EXHIBIT A  
SLBI Public  
Comments on OCS-  
EPA-R2 NJ 02

Regarding: EPA Permit Number OCS-EPA-R2 NJ 02.

Please see and consider the comments below from the Save Long Beach Island organization on the proposed Clean Air Act Outer Continental Shelf (OCS) air permit for the Atlantic Shores South offshore wind project.

**Figure 1**

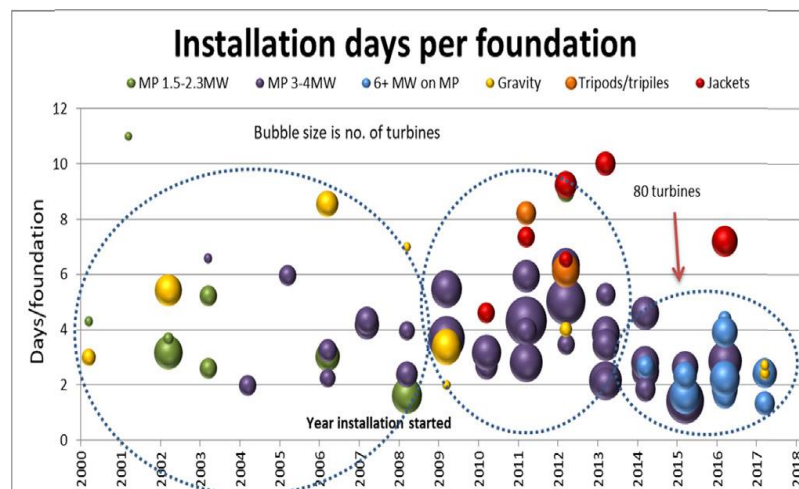
Overall picture of the time taken to install one foundation (without the turbine) for each OWF that has finished foundations installation.

As shown, the installation time for smaller 6-megawatt (MW) turbines on monopile foundations has leveled out at one every two days. It can only take longer for the larger diameter foundations here for the 15 MW turbine foundations here.

For those foundations, the two days per foundation is low because the steel surface area being driven into the seabed increases significantly for the larger turbines foundations here as opposed to the 6 MW turbines shown above.

approximately 12.3 ft.<sup>2</sup> as opposed to 3.6 ft.<sup>2</sup> for the 6 MW turbine, or 3.5 times as much. This is the area offering resistance to the pile driver. It is therefore reasonable to assume that it will take about three times as long to pile drive one of the 15 meter diameter foundations, as opposed to the 7.5 to 8 meter diameter foundations in the chart above.
